S. JOHNSON  
6/6/91

## R-392 Solid State FET Audio Replacement

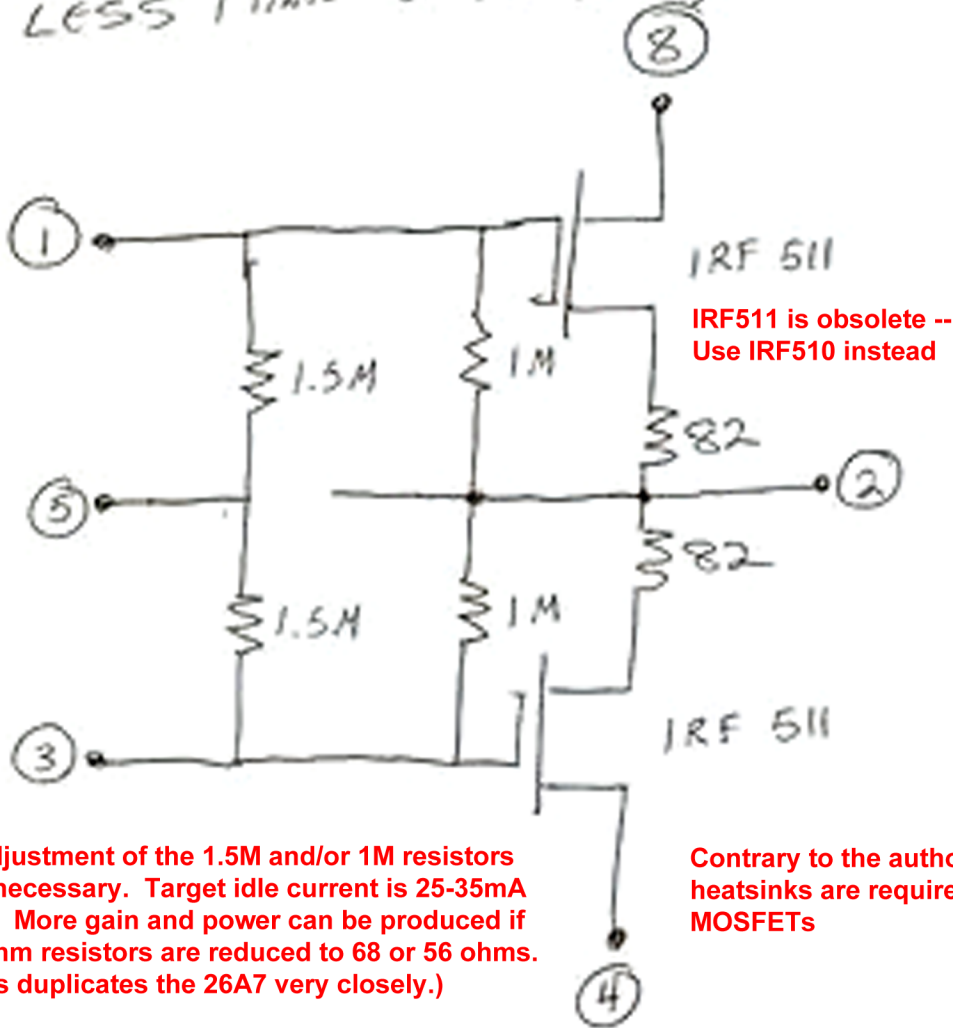
Contrary to the author's note, heatsinks are required for the MOSFETs
